Technical Memorandum 19-63

**A HUMAN ENGINEERING EVALUATION
OF THE
ML-1 & ML-1A MOBILE LOW POWER NUCLEAR POWER PLANT**

October 1963

Fig. 2A. PRESENT LUBE OIL SUMP TEMPERATURE METER

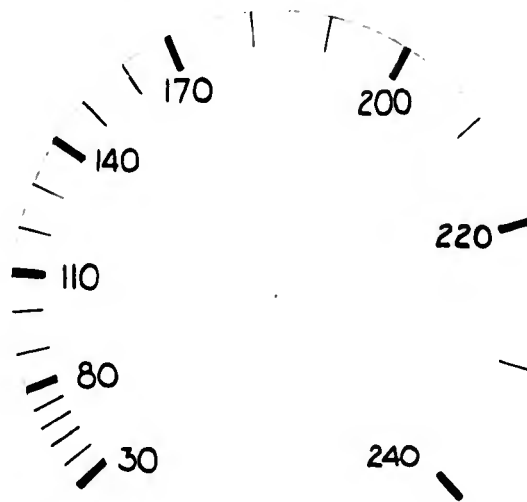
The scale of the lube oil sump temperature meter is poor. The present meter face is shown in Figure 2A. The scale markings on this meter do not follow good human factors principles.

The scale be redesigned as shown in Figure 3A.

Fig. 6A. CIRCUIT BREAKER "B"

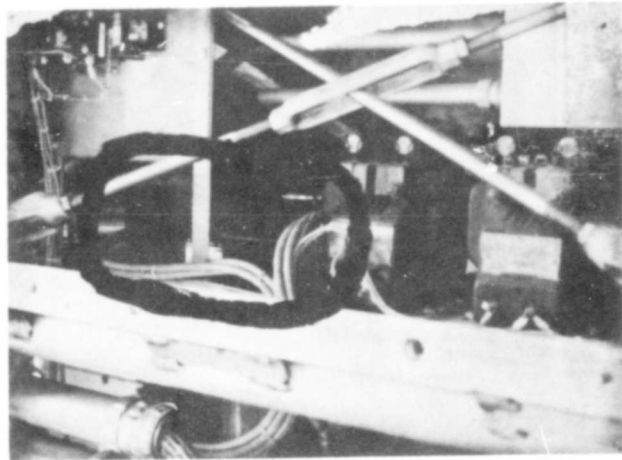
Both location and orientation of circuit breaker "B" are poor. In its present orientation (Fig. 6A), switch position labels, i.e., "ON" and "OFF", cannot be seen by the operators, which increases the error potential. Secondly, circuit breaker "B" is the only manually operated circuit breaker that is not located on the circuit-breaker panel. In order to provide for rapid identification of all system conditions and for access to circuit breakers, all manual circuit breakers should be located in one area.

Fig. 13A. SUMP EQUALIZING COMPRESSOR

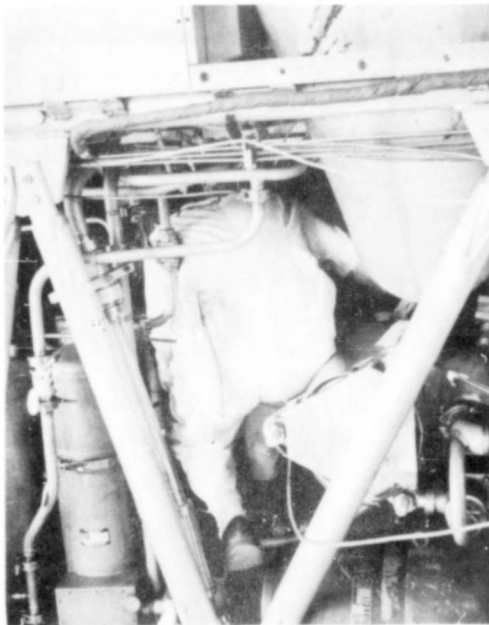
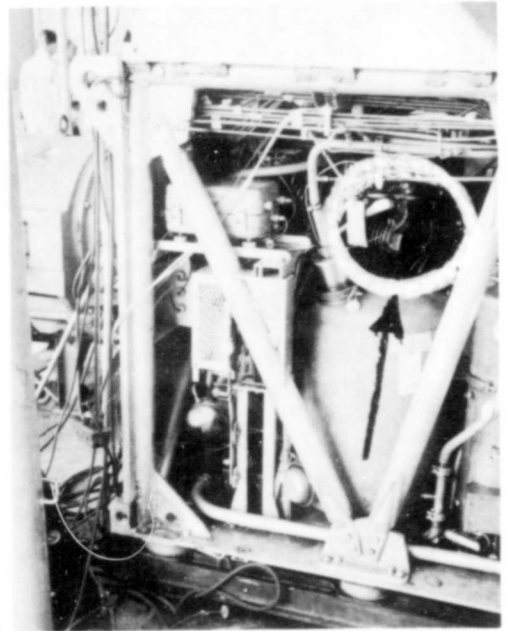
Access for oil check or oil fill on the sump equalizing compressor is poor. This compressor is mounted on the desiccant filter with its oil check and fill port on the rear of the compressor (Fig. 13A). The crewman must crawl "into" the skid to check or add oil (Fig. 14A).

Fig. 15A. FUSES AND CABLE RACEWAY

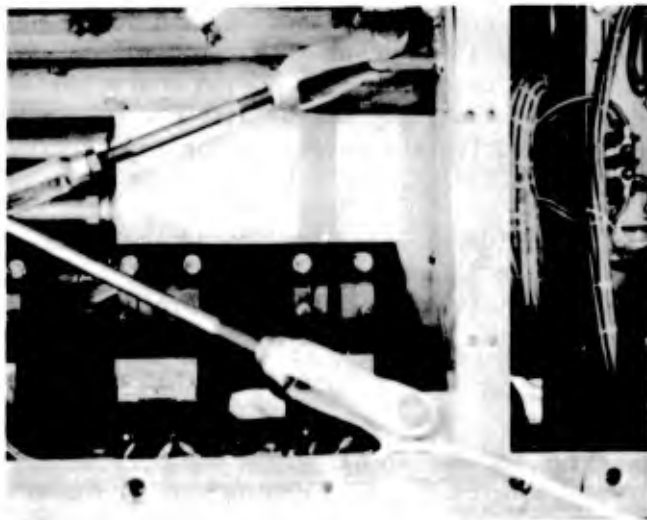
Sufficient clearance is not provided for replacement of some instrumentation fuses. These fuses are mounted on transformers located over the N₂ turbine inlet line. A cable raceway, directly over four of the six fuse holders, prohibits normal removal of the fuses (Fig. 15A). In order to remove a fuse, it would be necessary to spread the spring holder and pull the fuse out from the end. Replacement of the fuse would be performed similarly which could result in damage to the fuse.

Either the cable raceway or the transformers holding the fuses be relocated and, if possible, the transformers be mounted with the fuses vertical.

Fig. 19A. N₂ FILTER F-621

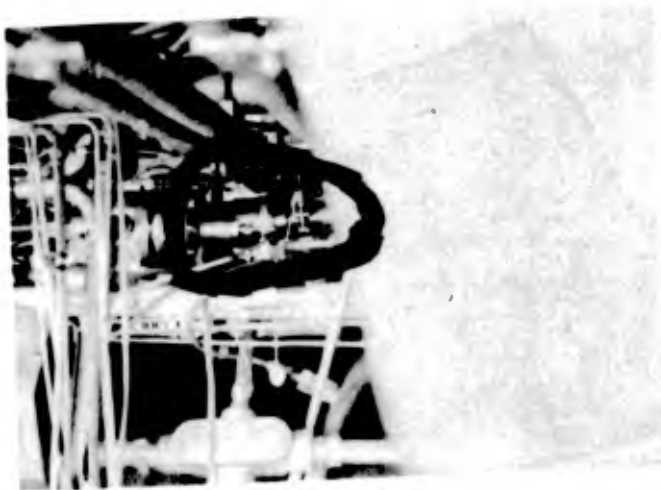
Accessibility to the N₂ filter, F-621 is extremely poor. The filter is mounted on the lube rack over the turbine-compressor at the approximate center of the skid (Fig. 19A). Access to the filter by personnel for removal and cleaning is awkward in that they must go "into" (Fig. 14A) the skid to remove the unit.

This filter be relocated to a more accessible position.
